## Roads Department – Planning Report

**Location:** Site within the townland of Ballymakailly, West of Newcastle Road (R120), Lucan, Co. Dublin  
**Applicant:** EdgeConneX Ireland Limited  
**App. Type:** Permission  
**Planning Officer:** SARAH WATSON  
**Date Recd:** 24-Feb-2021  
**Decision Due Date:** 20-Apr-2021

shown below; on the left; permitted under SD19/0042; and on the right proposed under this application:

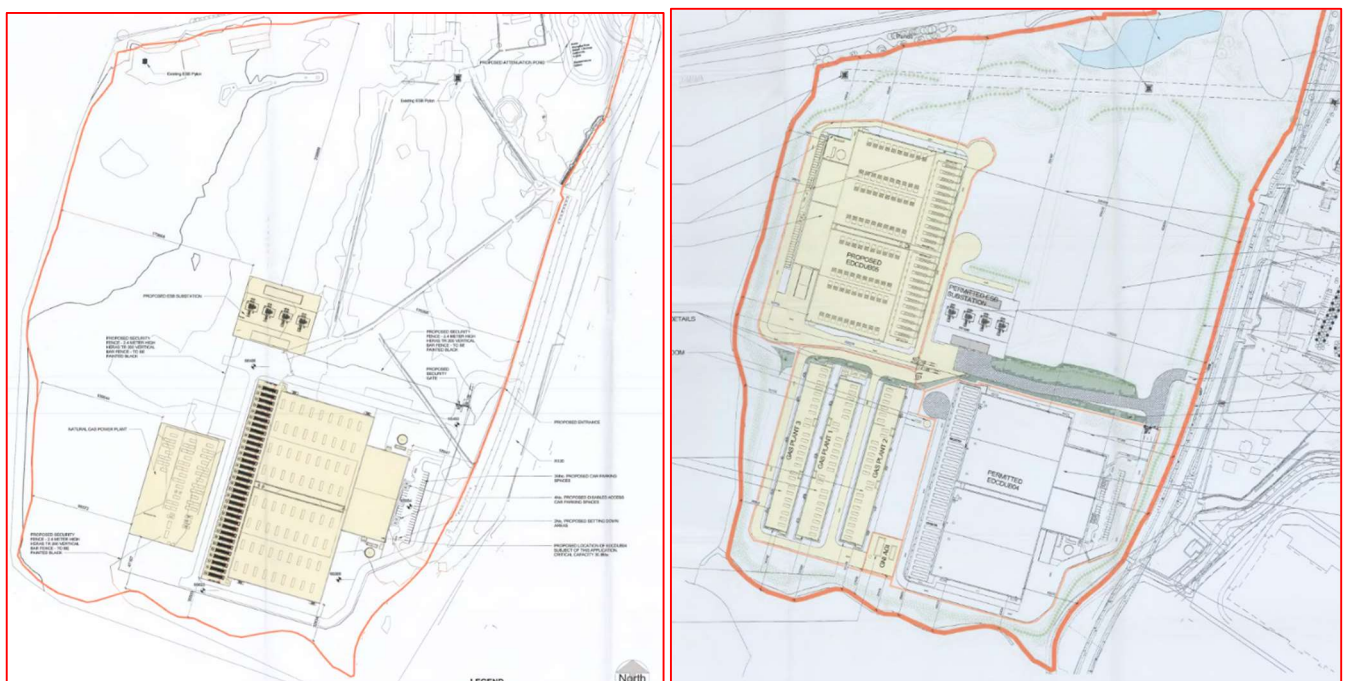
- Amendments to the internal access road and,
- Omission of access to loading bay permitted under SDCC planning Ref: SD19/0042 /ABP Ref. PL06S.305948 that include the relocation of permitted, and new, internal security gates; and new internal access roads to serve the proposed development
- Provision of 39no. new car parking spaces
  - o Including 4 electric and
  - o 2 disabled spaces
  - o and sheltered bicycle parking to serve the new data centres
